1 Products affected

2 Type of change

Product Change Notification					PCN KEA		
owner	creation date	release date	released by	change order no	rev	page	D10-011-720
hotzar	2016-12-19	2016-12-19	hotzar	2011741	A	1 of 2

Label adjustment:

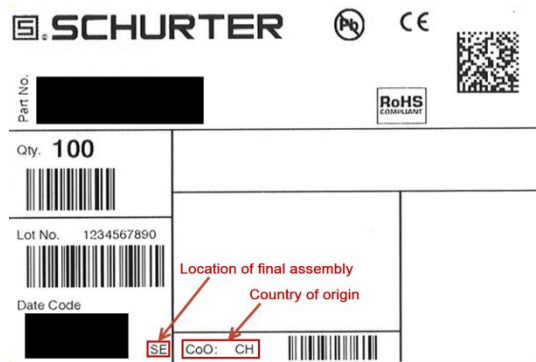
The location of final assembly and the country of origin of various fuse holders has changed from Switzerland to Czech Republic.

Form	No	No change in form
Fit	No	No change for dimension
Function	No	No change in function
Production Site	Yes	Change of final assembly from CH manufacturing site to CZ manufacturing site
Label	Yes	Modified label for change of location of final assembly and country of origin
Packaging	No	No change in packaging
